# Environmental Impact Statement

Request for Project Change 4

April 2019

**Queensland**  
Government

Figure 3.18: Changed Location of CRR Woolloongabba Station

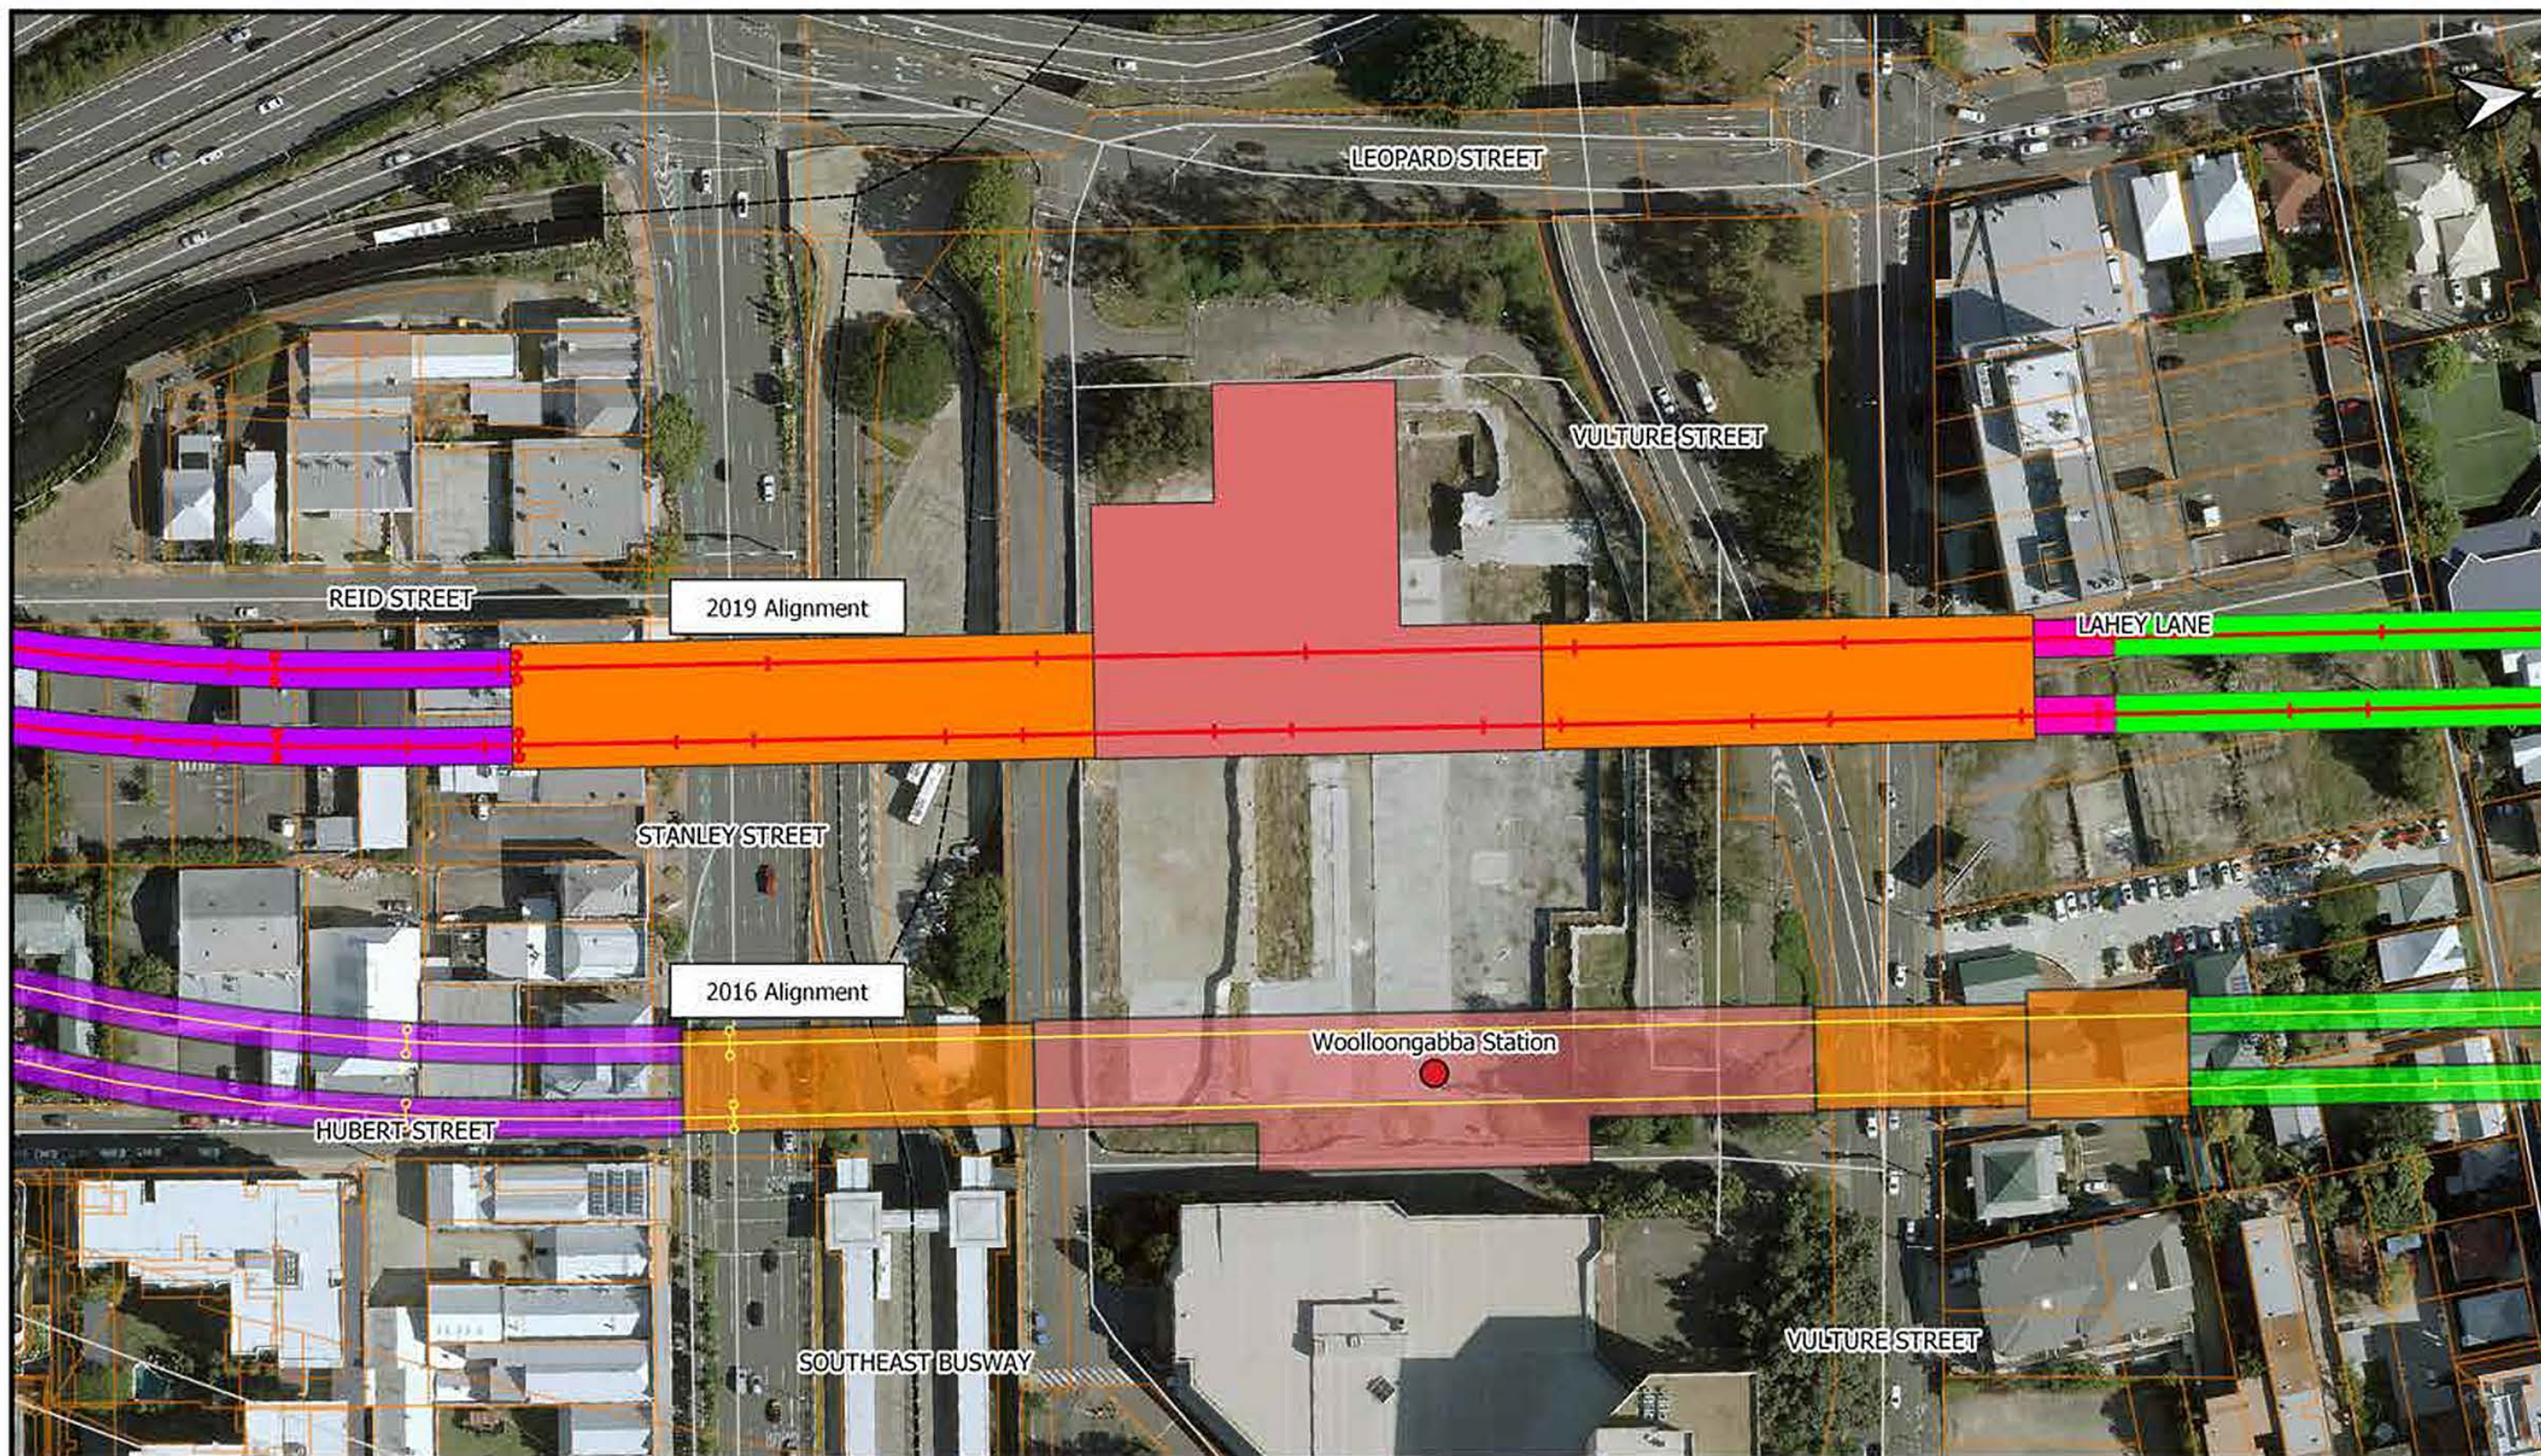
The Proposed Changes shift the CRR Woolloongabba Station approximately 70m to the west of the Evaluated Project. The surface entrance building is located further to the south on the former Go-Print site compared to the Evaluated Project, as shown in Figure 3.18. This new location increases the distance to The Gabba to 320m providing more open space for public realm, supports pedestrian management of event crowds including integrating with a station to Gabba stadium connection, facilitates connectivity with the larger Woolloongabba precinct, improves integration with Woolloongabba bus station and allows for future integration with Brisbane Metro infrastructure. The result of the relocation accommodates the straightened tunnel alignment.

Station access is proposed within a pavilion building with a paid concourse, rather than multiple individual entry points from an open public space as proposed in the Evaluated Project. The design minimises the station footprint (400m<sup>2</sup>) and plaza footprint (7,600m<sup>2</sup>) allowing the planning objectives for the Woolloongabba PDA to be realised. The plaza connection across the existing busway has been reconfigured with a new pedestrian access bridge between Woolloongabba Station and Stanley Street over the busway. To avoid altering the existing retaining walls on the busway a new reinforced earth wall will be installed 5m behind the retaining walls.

Figure 3.22: General Perspective of Boggo Road Station

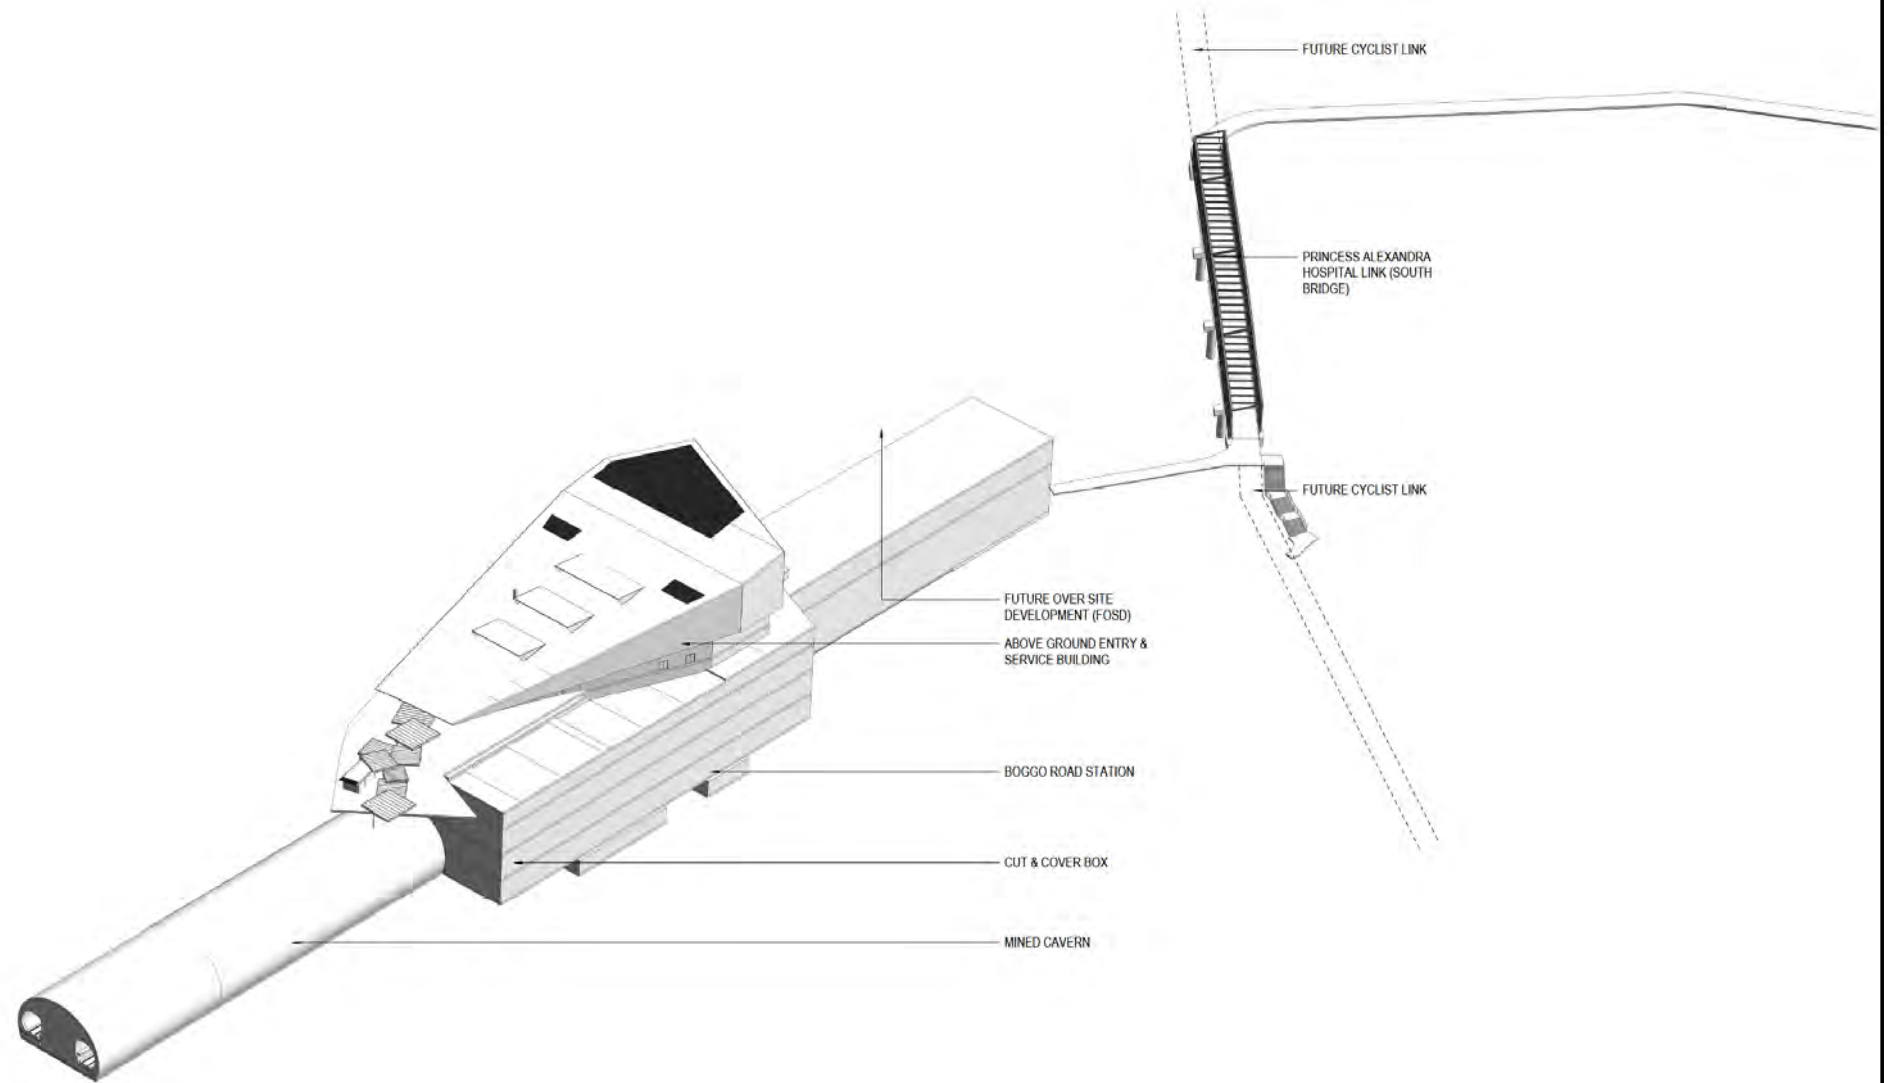
The key Proposed Change is the replacement of the proposed pedestrian underpass connection with a new elevated surface pedestrian and cycle link (bridge) from the PA Hospital to the Boggo Road Urban Village. The bridge spans from Joe Baker Street over the existing rail providing a 5.4m clearance and connects with the existing cycleway adjacent to the Boggo Road Busway. Other Proposed Changes to the design of the Boggo Road Station include:

- Lowering the station, extending the station cavern shifting the station box and platforms north by approximately 25m to avoid conflict with the Eastern Busway and freight flyover on the Port of Brisbane line;
- Rail alignment flattened and lowered to create a level platform improving safety and operations; and
- Relocation of plant and services underground minimising ground level area requirements.

Figure 3.21 shows a visualisation of the Proposed Changes to the Boggo Road Station entrance and Figure 3.22 a general perspective of the station.

Figure 3.24 - Clapham Yard Stabling Facility - Proposed

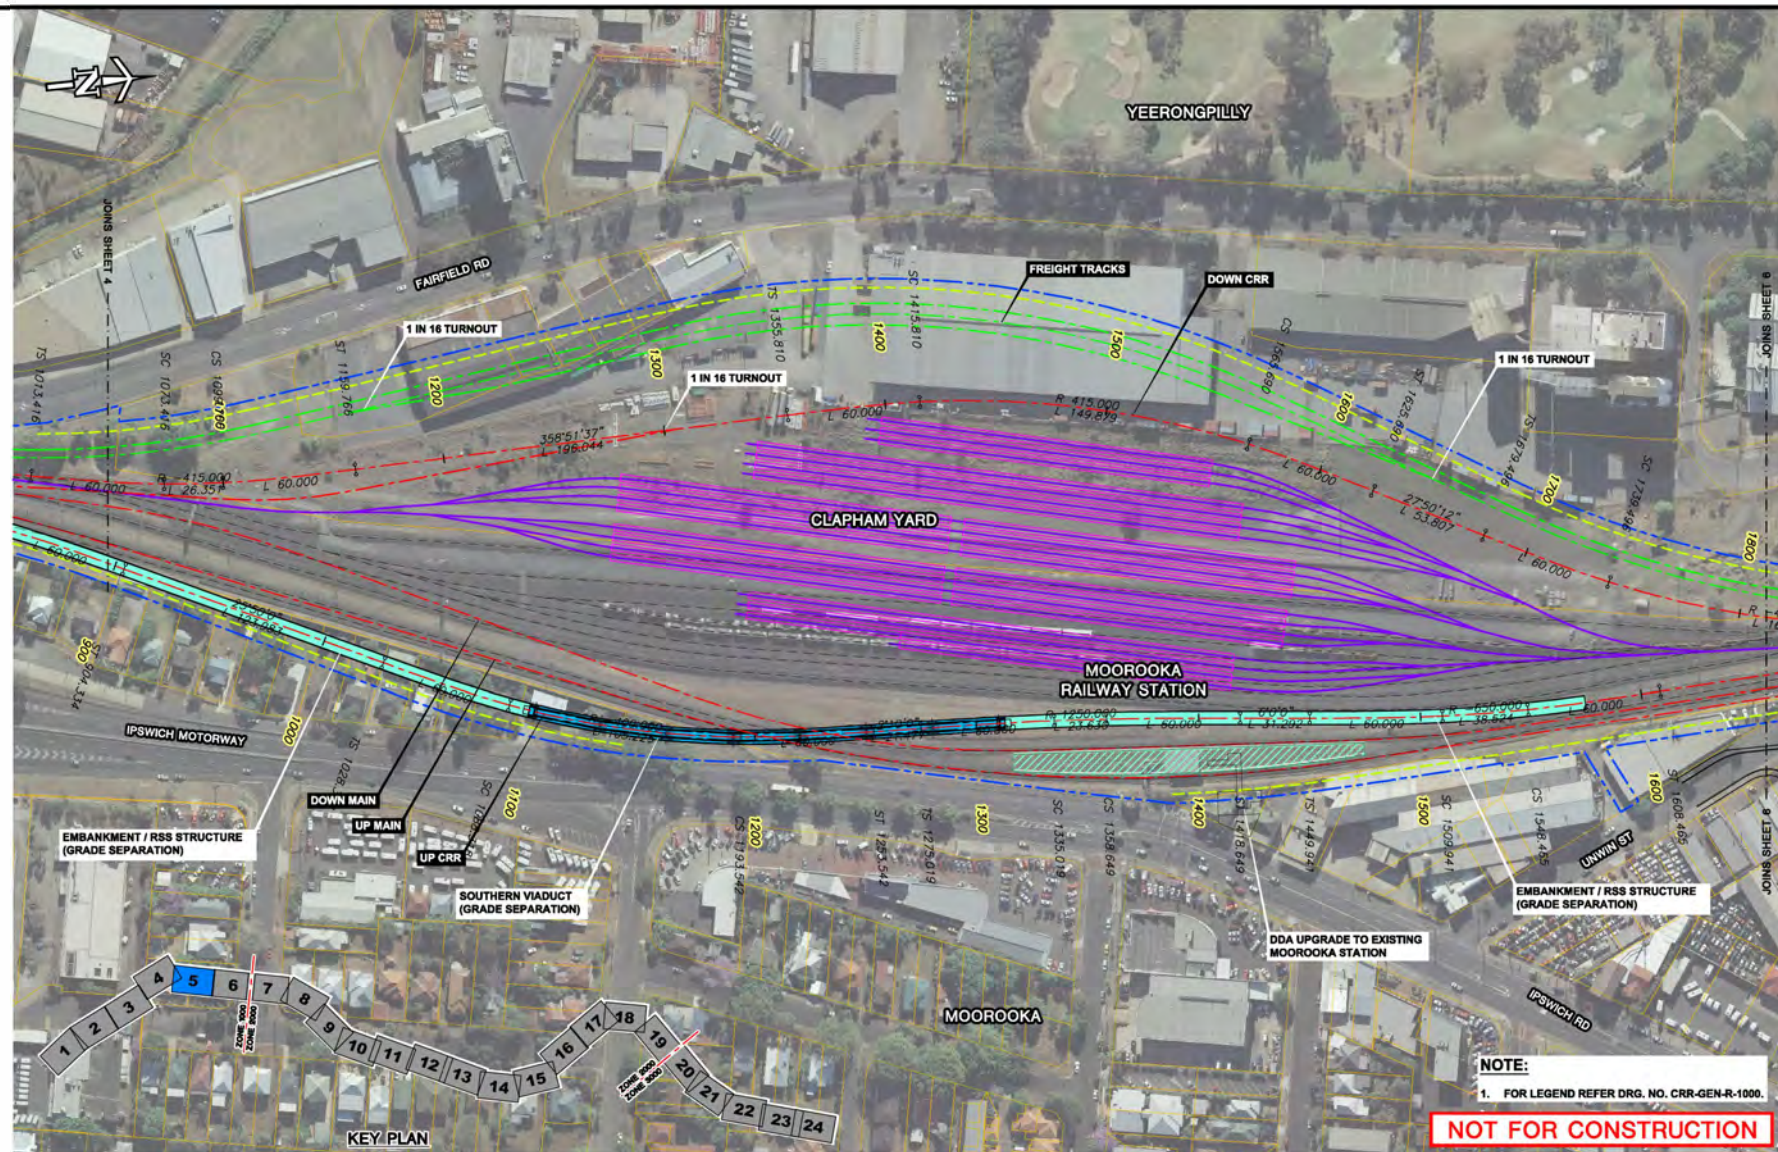
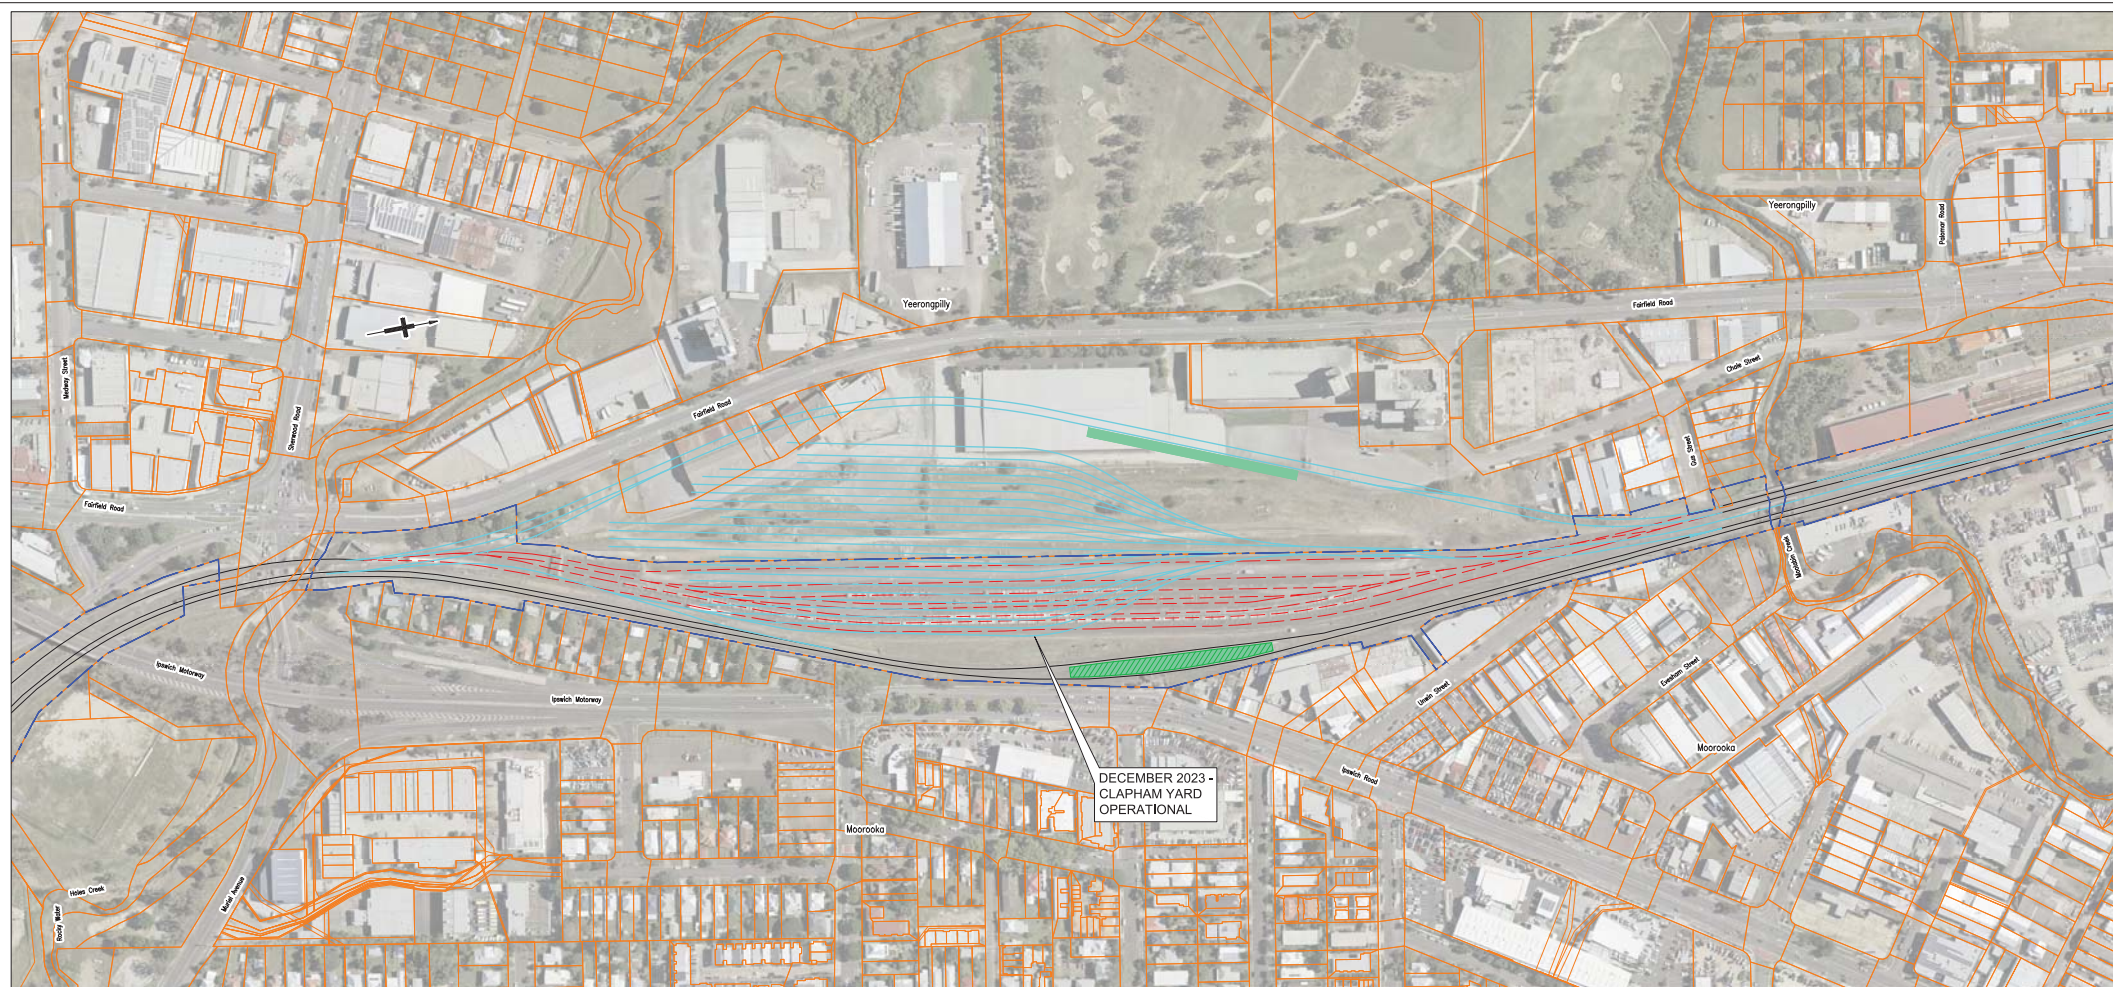
The 2011 EIS assessed a new stabling facility at Clapham Yard. This included new CRR lines, relocated dual gauge freight lines passing east of the yard to an alignment passing west of the yard, as well as a new train stabling facility as shown in Figure 3.23. This new stabling facility was subsequently removed from the Evaluated Project scope in the RfPC-1. Under the Evaluated Project, Clapham Yard was proposed to be developed and commissioned as part of wider network enhancements, by others.

Stabling facilities at Clapham Yard are required to support network operations across the rail network, including for CRR. Similar to the 2011 EIS design, the proposed works includes the relocation of the dual gauge and dual gauge loop to the west of Clapham Yard, a new rail bridge over Moolabin Creek and new stabling and facilities, as shown in Figure 3.24. Details of the design and delivery aspects of the proposed new Clapham Yard are outlined in Table 3.2.

Aspect	Proposed Change
Stabling facility	The design includes capacity for a total of 27 stabling roads accommodating slots for both 9 and 6 car train sets. It will also provide one stabling road for graffiti removal suitable for both 9-car CRR train sets and non-NGR train sets. The stabling yard will allow for windscreen and internal cleaning facilities with northern access and restricted southern access for rollingstock  Crew facilities and administration buildings would also be provided as required
Surface tracks	New dual gauge track and dual gauge loop to the western side of Clapham Yard with new turnouts to be installed on the suburban lines to provide access to the new yard. The new dual gauge tracks will carry passengers to the new Moorooka Station Platform.
Rail bridge	One additional track is required across Moolabin Creek with a new single track bridge over Moolabin Creek provided between the existing bridges with the piers aligned to avoid potential afflux issues. These works are similar in nature to that evaluated under the 2011 EIS.
